**STAFF REPORT**  
**COMMUNITY DEVELOPMENT DEPARTMENT**

DATE: 3/1/2022  
 TO: Mayor & City Council  
 FROM: Joseph Dodson, Associate Planner  
 208-884-5533  
 SUBJECT: FP-2022-0002  
 Meridian Movado Village

A final plat consisting of 5 building lots (3 commercial lots and 2 multi-family residential lots) on 6.8 acres of land in the C-G zoning district.

B. Final Plat (dated: January 10, 2022)

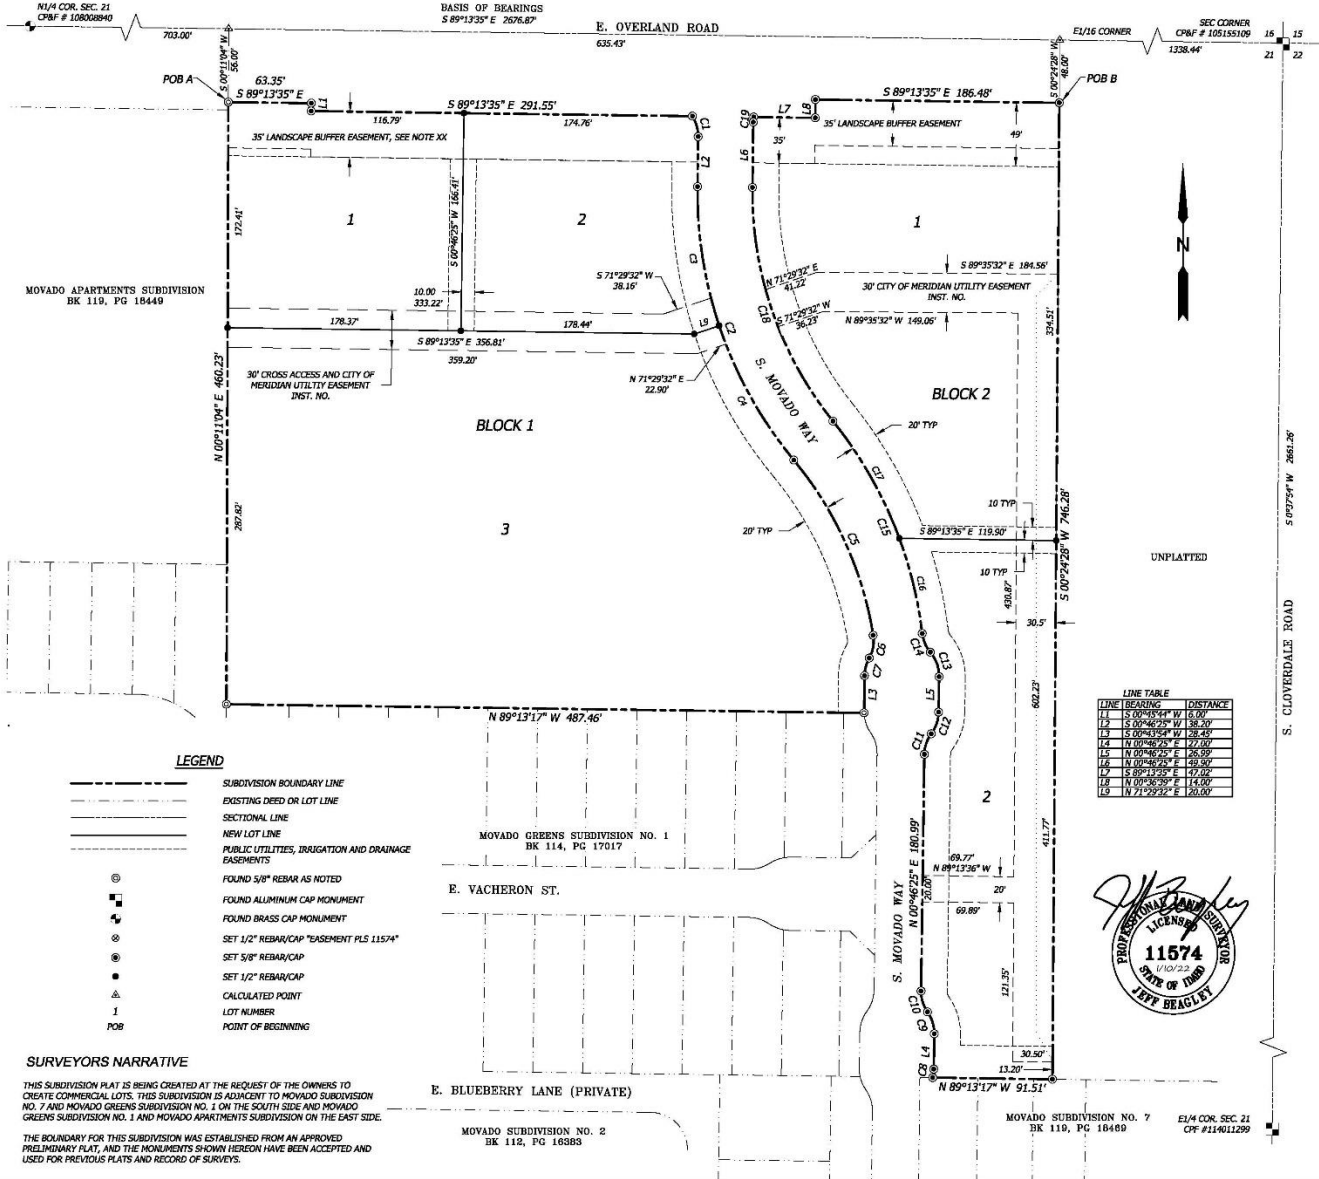
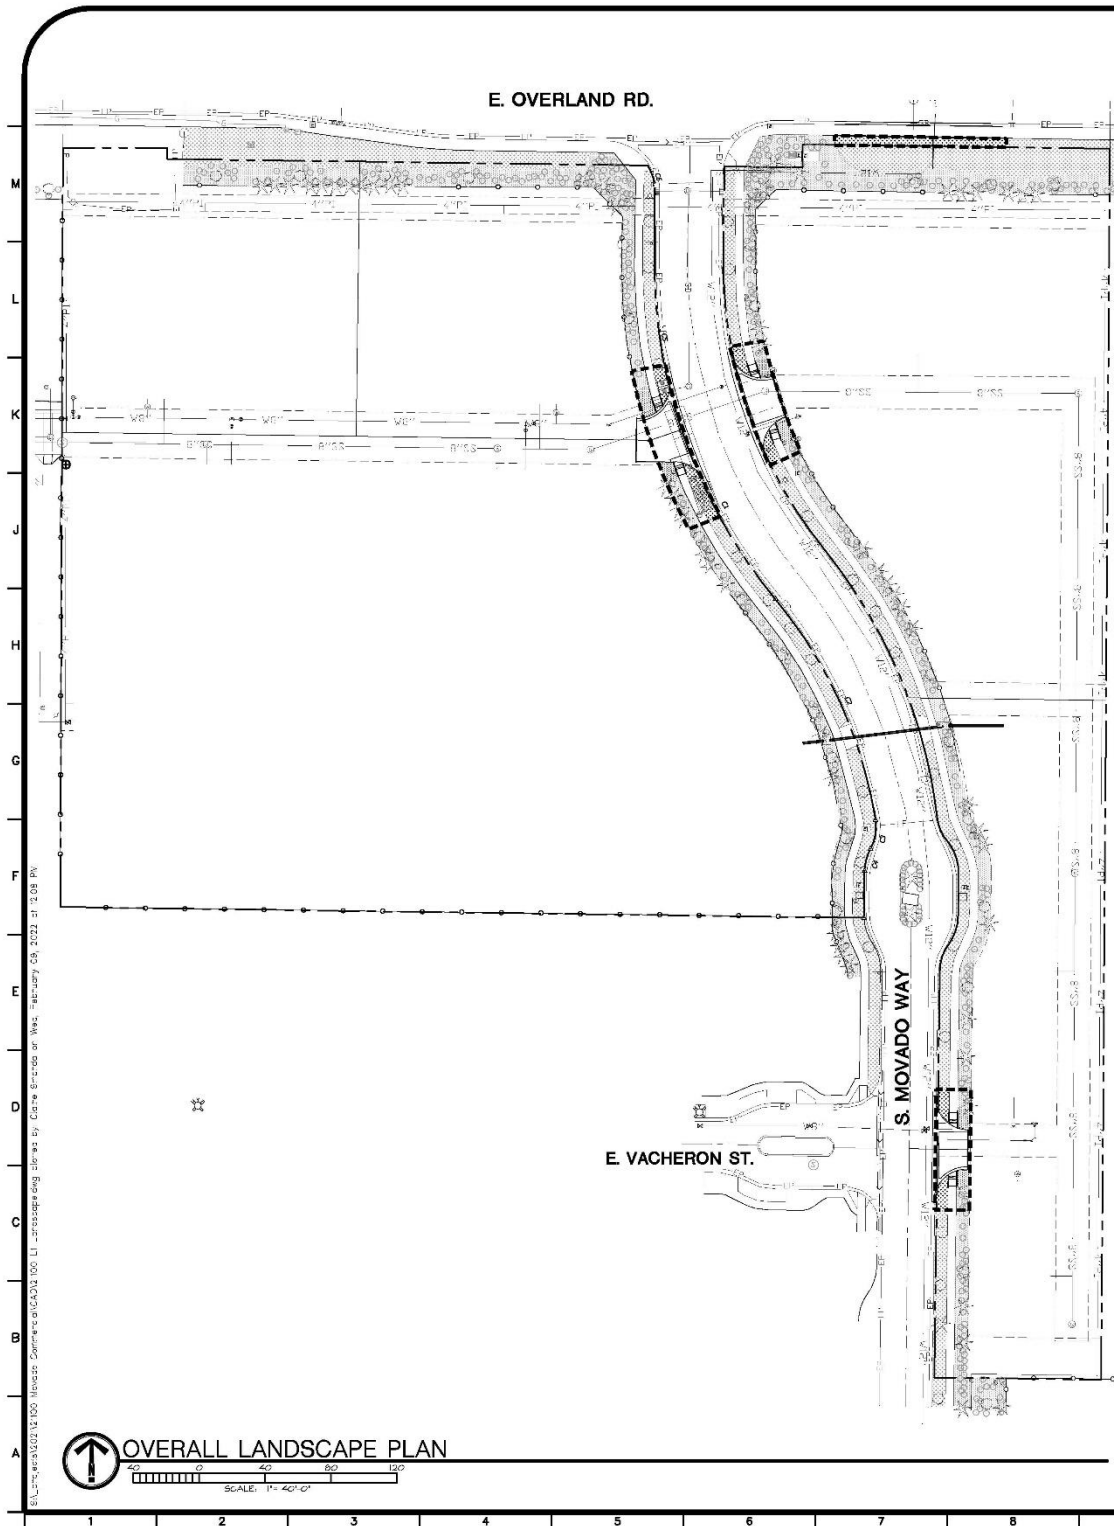
- a. Note #8: Include encumbered lots within this subdivision.
  - b. Note #11: Include the latest DA instrument number for these properties (2021-102395).

- c. Note #13: Include recorded instrument number.
  - d. Add a note addressing any shared parking and/or access between the commercial and multi-family lots. Provide a copy of the recorded shared parking/access agreement with the Planning Division at the time of Certificate of Zoning Compliance application submittal.

- e. Add a note addressing cross-access to the Boise parcel to the east (S1121110200), as required by the Development Agreement. Visually showing the location of this cross-access would also be a benefit.

3. Prior to submittal for the City Engineer's signature, have the Certificate of Owners and the accompanying acknowledgement signed and notarized.
4. Prior to signature on the final plat by the City Engineer, the final plat prepared by Sawtooth Land Surveying, LLC (Exhibit B), dated January 10, 2022, shall be revised as follows:

C. Landscape Plan (dated: January 12, 2022)

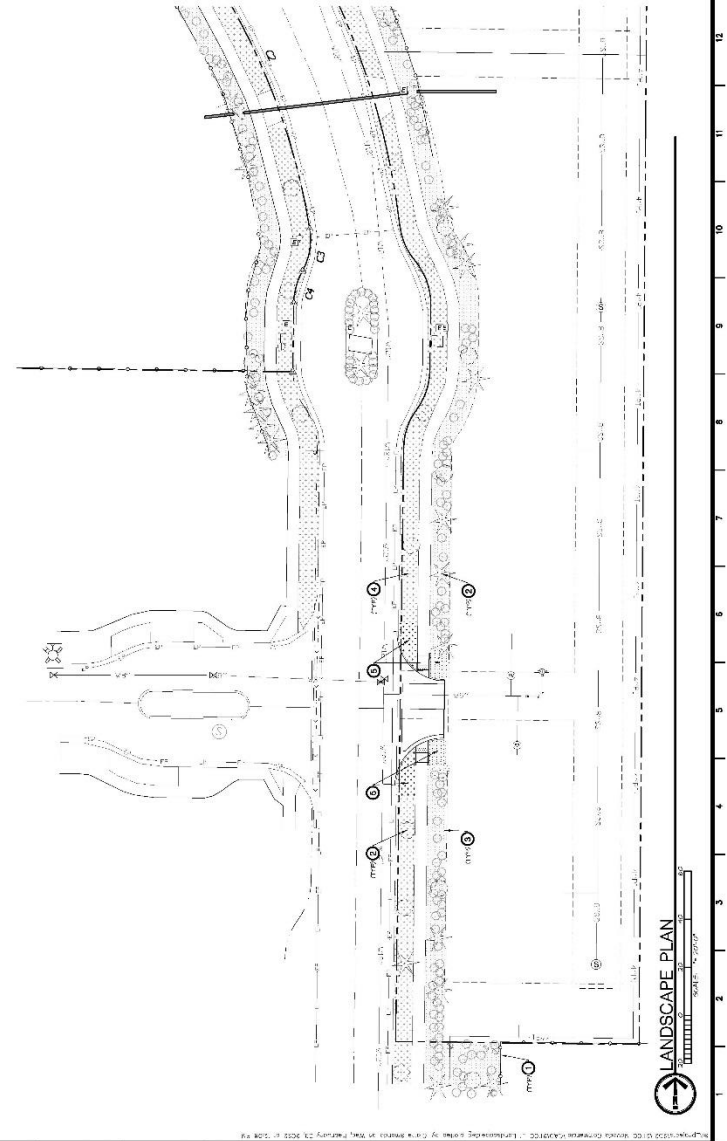
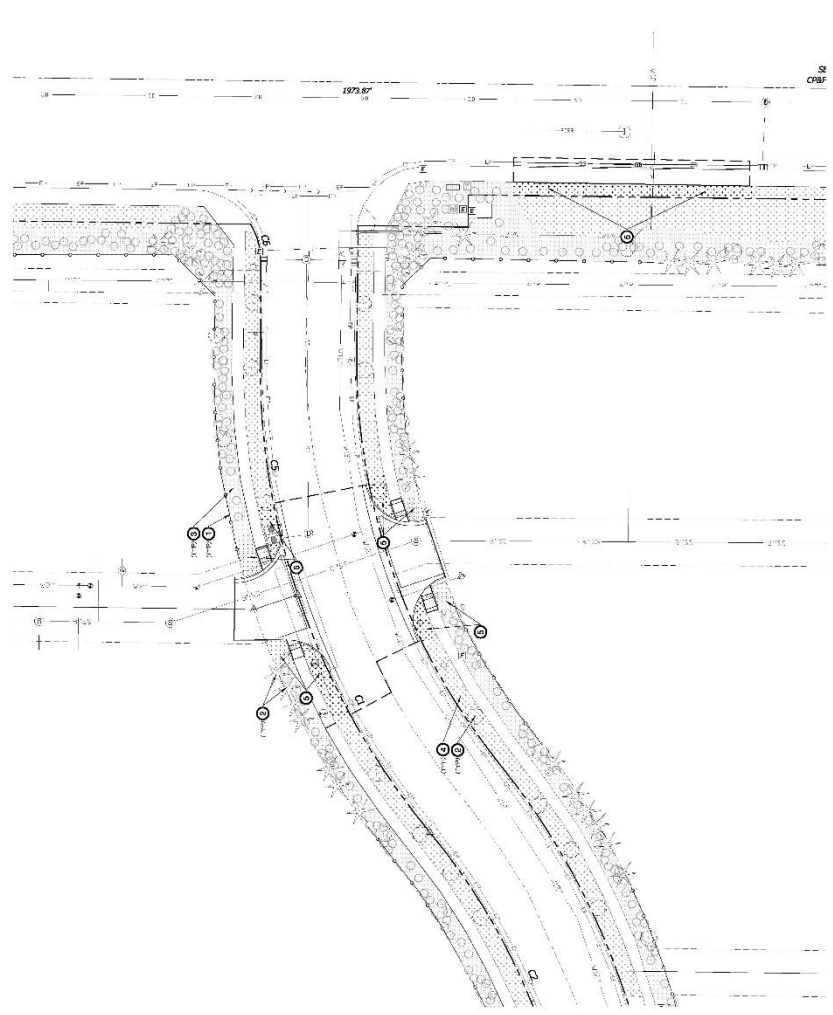
5. The landscape plan prepared by Breckon Land Design (Exhibit C), dated January 12, 2022, is approved as shown. All buffer landscaping has been installed and shall remain protected during construction.
